BOARD OF DIRECTORS

Board Minutes November 3, 2018

SOLO EVENTS BOARD | October 24th

Figure 1: SMG Strut housing with Slotted Upper Hole.
(Note: JRi housings have the slot on the bottom hole)

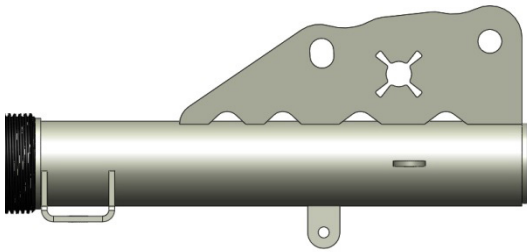
(4) Maximum negative front camber is 3.5 degrees. The approved technique to accomplish this is by using the Cortex P/N CFS-40-ALIGN-SMG, SMG Alignment kit (which includes camber slugs P/N CFS-40-1010), in all SMG strut housings. Installation guidelines are provided by Cortex Engineering. The JRi front strut housing will already have this feature. This CFS-40 kit is allowed, not required. But this IS the only allowed means to go beyond 3.0 degrees of negative camber. Potential tire clearance issues, resulting from this modification, are addressed in Section o). No machining of body to allow further travel. Caster: min. +6.35; max. +7.85. Camber plate PN MM5CC-5 or CCP197-05-09.

Illustration of strut housing modification discussed in section g) 4.
